**File #: SR 24-6, Version: 1**

Reviewing request of Owner, Alex Delendik, to a Vacant Building Registration Notice at 827 AGATE STREET.

Project: Review of Constructed Retaining Wall  
827 Agate St.  
St. Paul, MN  
PEC #6186

# 8" BLOCK WALL OPTION

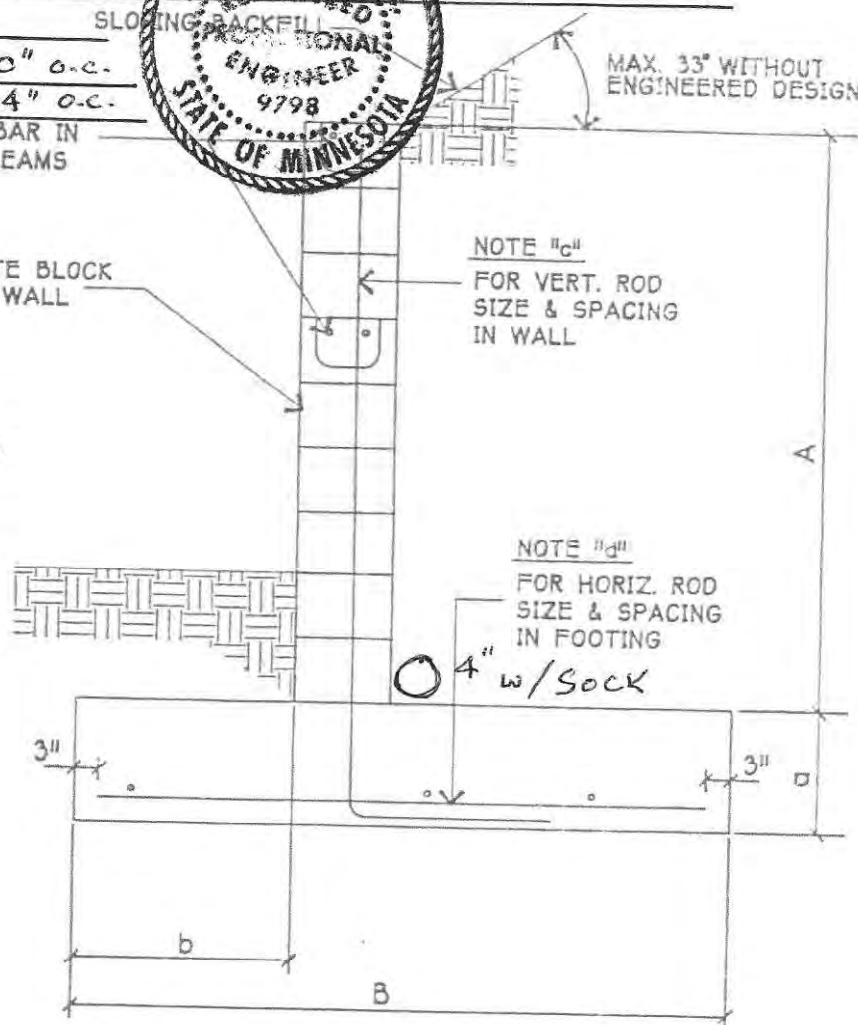
This report concerns our review of a constructed retaining wall behind the front sidewalk at 827 Agate St., St. Paul, MN. The property owner, Alexander Delendik, of Homestead Road LLC, performed his own construction of the wall in general conformance with a detail sheet entitled "8" Block Wall Option." However, the inspection department at the City of St. Paul required that the wall be inspected by a Registered Engineer who could answer to the construction requirements outlined in its identification sheet.

Over the last several weeks, the old retaining wall was demolished and the footing construction removed from the front stairway eastward to the east property line. This amounted to a retaining wall length of slightly less than 30', since a higher concrete retaining wall had been left in place to the west of the stairway. A new footing was dug in behind the sidewalk, providing a new footing which was approximately 12" deep and at least 32" from the existing front sidewalk toward the rear of the property. Reinforced concrete used 1/2" rebar for the longitudinal steel in three locations at the front of the footing, the rear of the footing, and half-way between these bars. The front and rear bars used a 3" cover of concrete to the dirt forms. The first course of 8" block was placed

in the wet concrete and the footing was stabbed with ½" bars spaced 20" on center toward the rear face of the concrete block first course.

Using this layout of block and rebar, successive courses of 8" concrete block, both double corner and common, were placed with a mason's mortar using a common bond pattern to top of wall height. The completed wall was approximately 4-1/2 courses in height. The vertical rebar were left at least 2 to 3" below top of wall. The completed wall section was then filled with a 4000 psi curb and gutter mix. The rear of the wall received a 4" corrugated drain tile with an exterior sock. The backfill material behind the wall was filled with a granular backfill material and then capped off with the natural excavated soils which consisted of a silty sand material with topsoil mix. The entire backfill region behind the wall was estimated as less than a 33% grade, and the entire backfill area received a grass mix and was covered by a straw mulch.

Since the entire project was completed just recently, the owner will also reseed in the springtime and will seed as needed for a grassy embankment. Based on our observations, the owner has protected the finished grade as much as possible and will continue with seeding and mulching this spring to establish a lawn. We informed the owner that such embankments should drain over the top of the wall and not behind the wall for maximum stability of the wall construction. It is our opinion the owner has used good workmanship on this construction.
